## ADDENDUM NO.3

### INVITATION FOR BIDS FOR CONSTRUCTION SERVICES FOR CAMARILLO STATION AMERICANS WITH DISABILITIES ACT (ADA) IMPROVEMENTS PROJECT

ISSUED June 8, 2026

SHEET XS-01

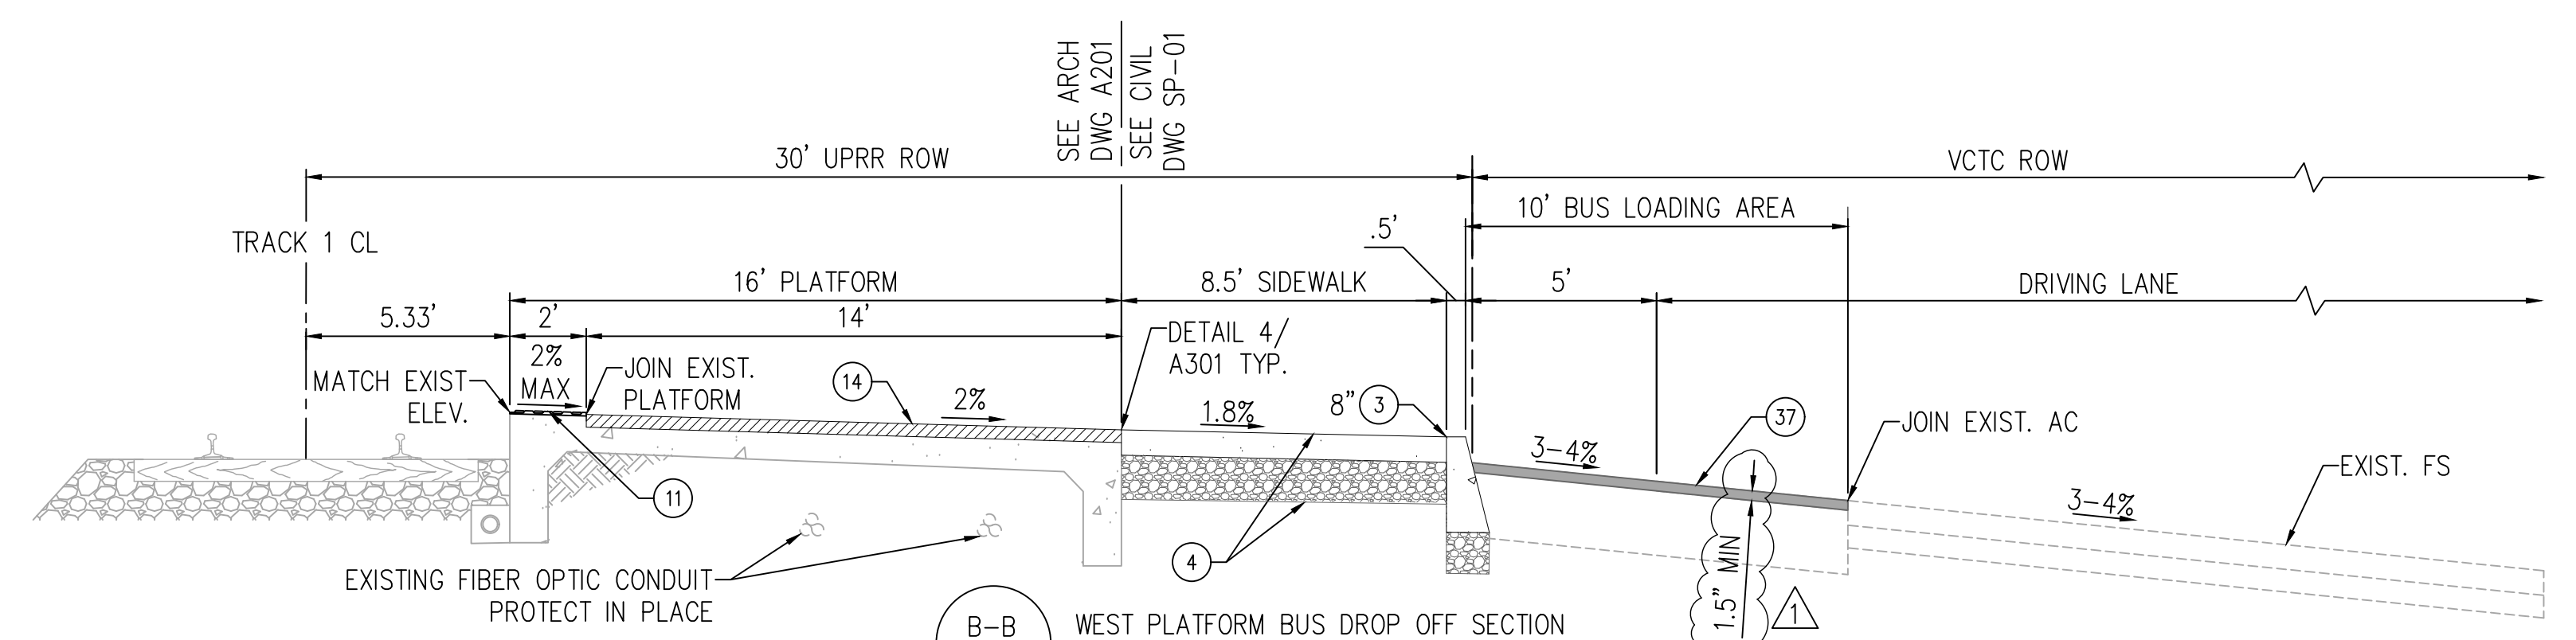
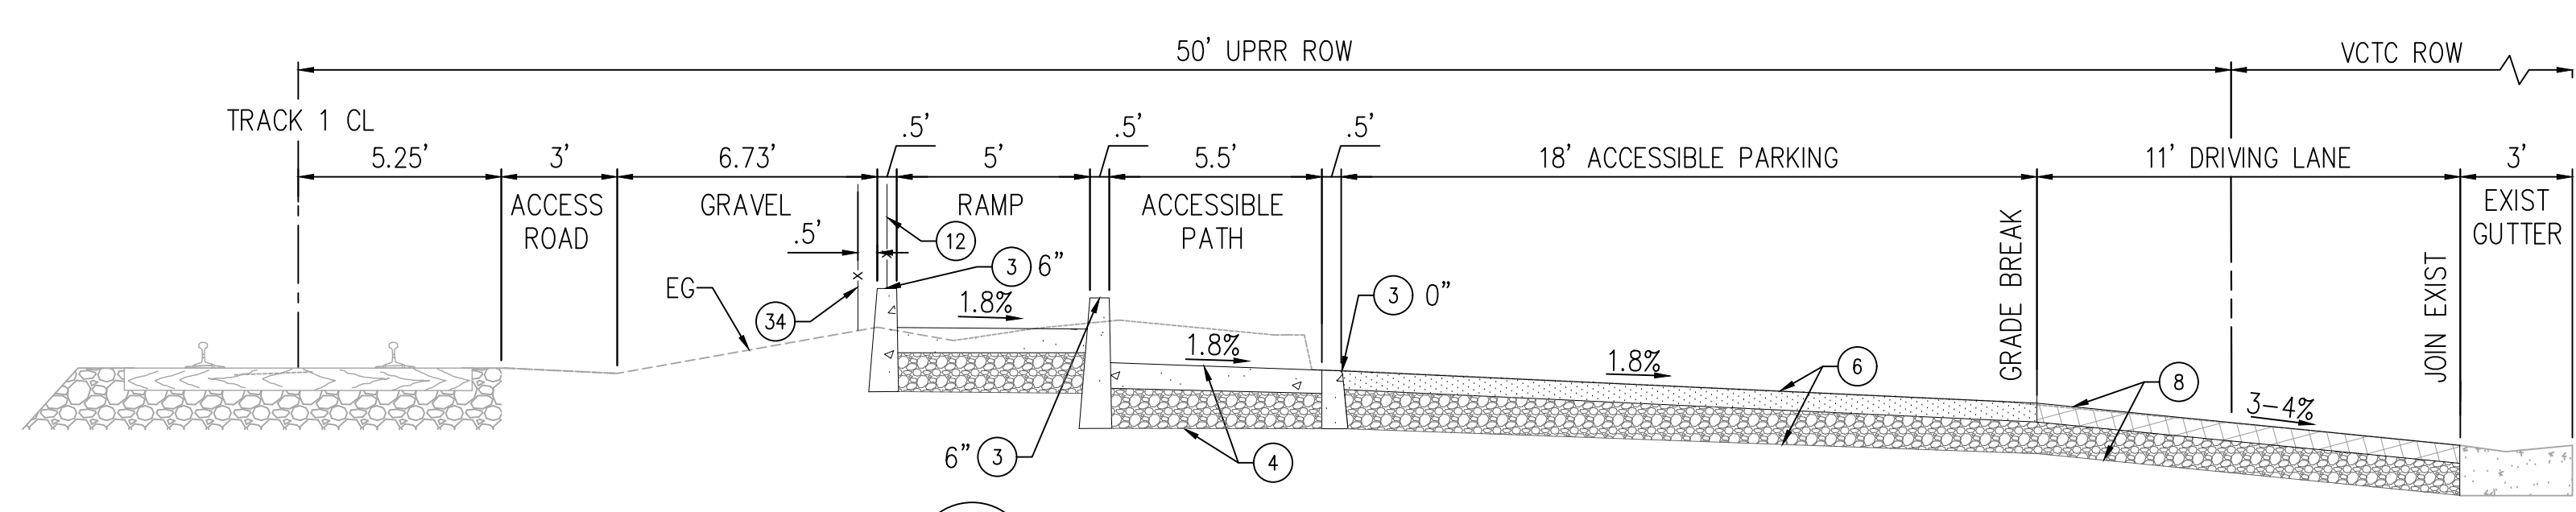
- a. XS-01 Civil Site Typical Sections
- b. DM-01 Demolition Plan Sheet 1 of 3
- c. DM-02 Demolition Plan Sheet 2 of 3
- d. DM-03 Demolition Plan Sheet 3 of 3
- e. SP-01 Civil Site Plan Sheet 1 of 3
- f. SP-02 Civil Site Plan Sheet 2 of 3
- g. SP-03 Civil Site Plan Sheet 3 of 3
- h. A203 Enlarged Platform Plan, Sheet 2 of 8
- i. A204 Enlarged Platform Plan, Sheet 3 of 8
- j. A206 Enlarged Platform Plan, Sheet 5 of 8
- k. A207 Enlarged Platform Plan, Sheet 6 of 8
- l. A208 Enlarged Platform Plan, Sheet 7 of 8
- m. A209 Enlarged Platform Plan, Sheet 8 of 8
- n. A304 Architectural Details, Sheet 4 of 5

Question No. 9	
QUESTION:	What is Minimum thickness required for the Mill & Overlay of the bus loading area as shown the plans as construction note 37? Are we just to remove the existing asphalt on the concrete and replace it? Or is concrete grinding anticipated?
RESPONSE:	Minimum thickness of grind and overlay shall be 1.5 inches. Asphalt shall be completely removed, and minor concrete grinding is anticipated in the same operation. The surface of concrete bus pad shall be roughened during the same grinding operation. Apply tack coat prior to installing final wearing layer of AC per the specifications. See updated XS-01 as part of Addendum #3.
